PERFORMANCE SPECIFICATION SHEET

EARPHONE ELEMENT,
HIGH AND LOW-ALTITUDE, H-143/AIC
AND LOW-ALTITUDE, WATER-IMMERSIBLE, H-143A/AIC

This amendment forms part of Specification Sheet MIL- PRF-25670/2A, dated 30 May 1997, and is approved by all Departments and Agencies of the Department of Defense.

FIGURE 4. 25,000 ft. frequency response envelope for earphone H-143/AIC.

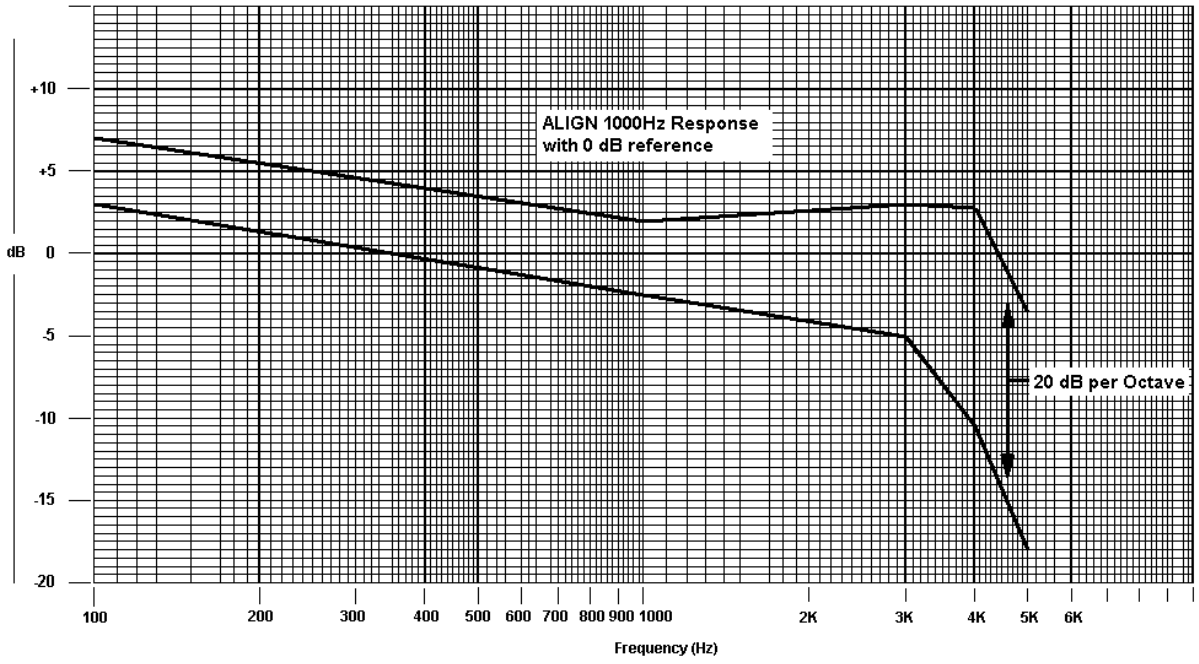
FIGURE 4. Delete and substitute the following:

TABLE II. Key points for 25,000 ft. altitude. (Figure 4)

| FIGURE 4. 25,000 FT FREQUENCY RESPONSE KEY BREAK POINTS DIGITIZED. | | | | | |
| FREQUENCY POINTS | 100 Hz | 1,000 Hz | 3,000 Hz | 4,000 Hz | 5,000 Hz |
| UPPER LIMIT dB | +7.0 | +2.0 | +3.0 | +2.75 | -3.50 |
| LOWER LIMIT dB | +3.0 | -2.50 | -5.0 | -10.50 | -18.00 |
